## **OLEANDER PARK SUBDIVISION**

The purpose of this application is to create a 2-lot subdivision from a metes and bounds parcel.

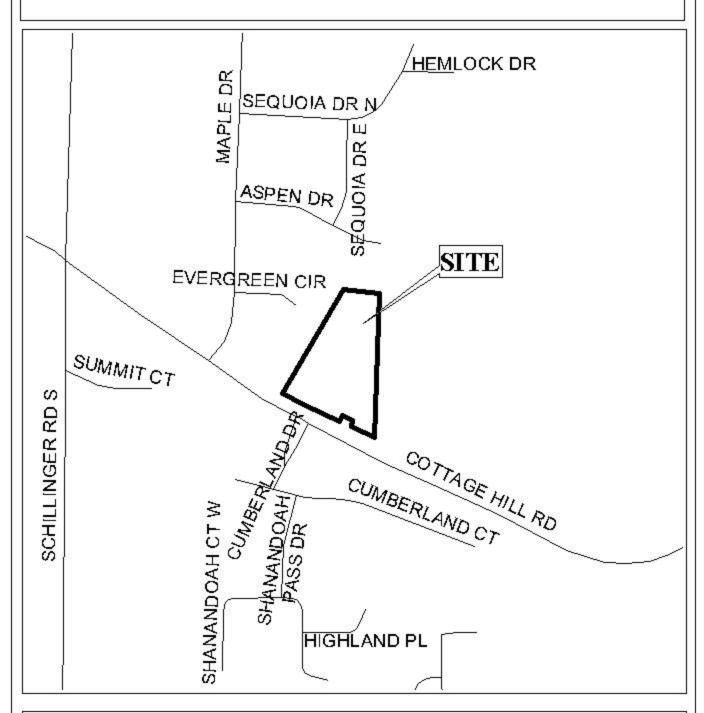
With Lots 1 & 2 having a large amount of frontage on a major street, access management is a concern; therefore, Lots 1 and 2 should be limited to one curb cut each to Cottage Hill Road, with size, location, and design to be approved by County Engineering.

As indicated on the Detail Map, wetlands are located on this site and as such the area may be considered environmentally sensitive; therefore, the approval of any necessary federal, state and local agencies would be required.

This site is located in the County, thus a note should be placed on the final plat stating that any lots which are developed commercially and adjoin residentially developed property must provide a buffer in compliance with Section V.A.7. of the Subdivision Regulations.

The plat meets the minimum requirements of the Subdivision Regulations and is recommended for Tentative Approval subject to the following conditions: 1) the placement of a note on the final plat stating that Lots 1 and 2 are limited to one curb cut each to Cottage Hill Road, with the size, location, and design to be approved by County Engineering Department; 2) the developer to obtain the necessary approvals from federal, state and local agencies prior to the issuance of any permits; and 3) the placement of a note on the final plat stating that if any property is developed commercially and adjoins residential property will provide a buffer in compliance with Section V.A.7. of the Subdivision Regulations.
